City of Hamilton  
71 Main Street West  
Hamilton, L8P 4Y5

**Re: ZAC-21-049 and UHOPA-21-023**  
**442 to 462 Wilson Street East**

The Sun Shadow Study included in the application provides more detail, but this extract from Page 16 of the applicant’s shadow study (shadows at 4:50 PM March 21) illustrates the issue.

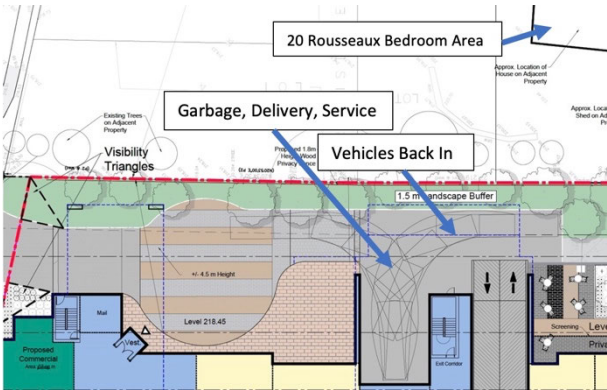
A 9 meter high development provided for by C5a (570) zoning would cast shadows as shown by the yellow shading, which would have limited impact on existing **existing trees and vegetation.**

However, the excessive height of the proposed over-built structures causes shadowing as shown in blue shading. It envelops the back area of our home, and fully shadows the open lots 3 and 4 (see the diagram on page 3) so any future homes would be in full shadow front and back.

Only the equinox shadowing is provided in the shadow study, but it is easy to extrapolate to prime outdoor season in summer when this shadowing will be very evident. **The excessive shadow is caused by the excessive height of the proposed building and would not be an issue if structures were built according to the Official Plan and zoning requirements.**

**HVAC Noise Impacts**

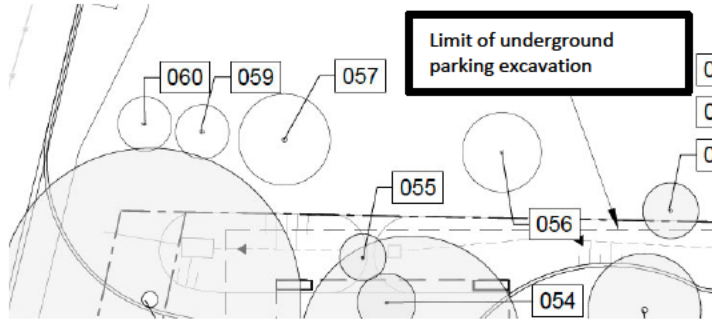
Air handling equipment must be shielded from Rousseaux Street view, but any visual screen will not control the noise from the required HVAC units on the roof of the building. Page 34 PED 22037 states there will be further investigation. This type of noise issue is a significant problem in many places where large buildings are adjacent to residential uses. There may not be a solution--it is the size of the building that will dictate the need for very large industrial units. This would not be an issue with individual three storey buildings provided for in the Secondary Plan and zoning.

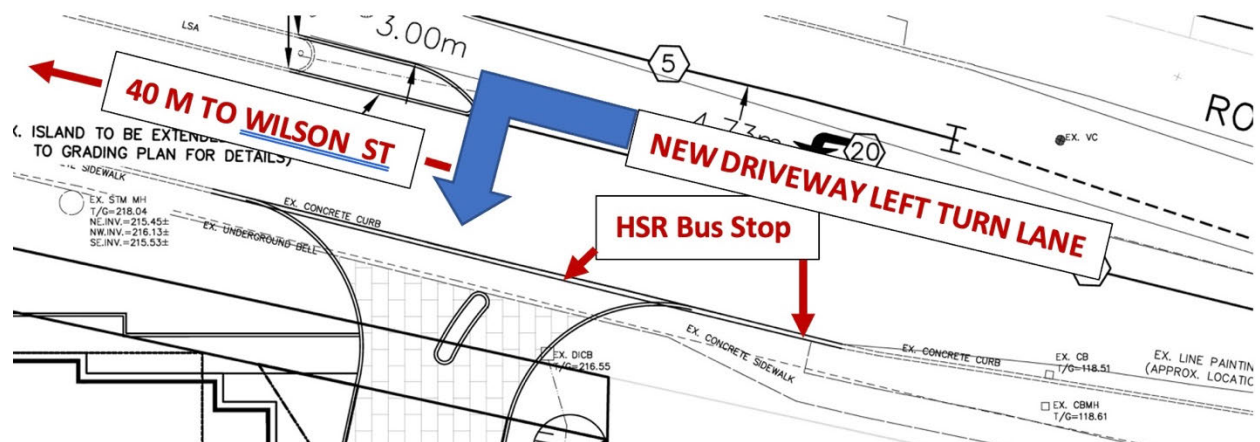
This is easy to understand. The excavation for the parking garage will be to the lot line as shown in the Vegetation Management diagram and tree roots do not respect lot boundaries.

Bylaw C5a requires a 3 meter planted buffer between this development and the adjoining ER zoned land--this is shown as 1.5 meters in the Vegetation Management Plan, and it appears the turn circle encroaches into it. The buffer will be on top of the parking garage roof, so vegetation will have very limited root depth.

The large trees shown in the Page 3 and 4 rendering above will not likely be in place immediately after construction or perhaps ever due to space constraints. The trees would be located in the buffer zone and therefore their potential root depth is compromised in terms of

the depth of soil in this area. In addition, the aforementioned significant shadowing may impact the ability for the vegetative buffers to excel and grow quickly. For these reasons, the rendering on Page 4 is highly misleading. In fact almost the entire building will be in open view.

**This applicant must be held to strict adherence to the 7.5 meter setback and 3 meter buffer.**

**Figure 2: Existing Daily Traffic Volumes**

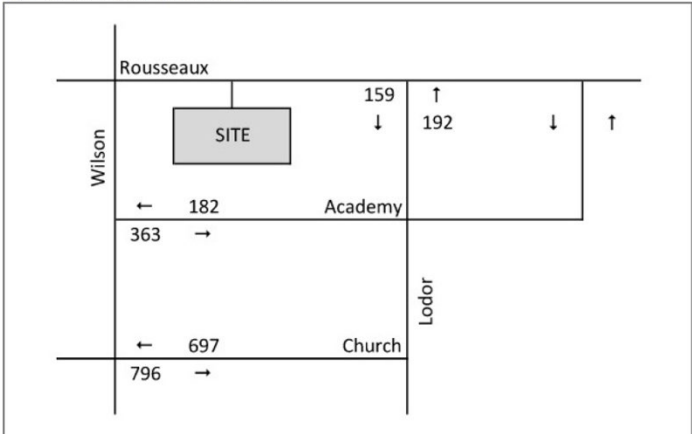
However, the reason the applicant is proposing the left turn option is simple. The Salvini Report Table 4 (below) and Figure 2 illustrates the traffic volume issues.

With Left Turn inbound permitted the 50% of site traffic estimated to/from the east can turn directly into the driveway.

If this is not permitted, the 50% from the east and the 15% from the north on Wilson will travel south on Lodor, west on Church (traffic prefers Church as there are lights at Wilson), then north on Wilson to Rousseaux then a right turn in.

**It seems obvious the congested, dangerous proposal to allow left turns from Rousseaux Street is proposed as otherwise 65% of the inbound traffic and 40% of the outbound traffic will be forced to use narrow local streets that already have a serious issue with rush hour traffic cutting through to avoid the Wilson/Rousseaux intersection.**
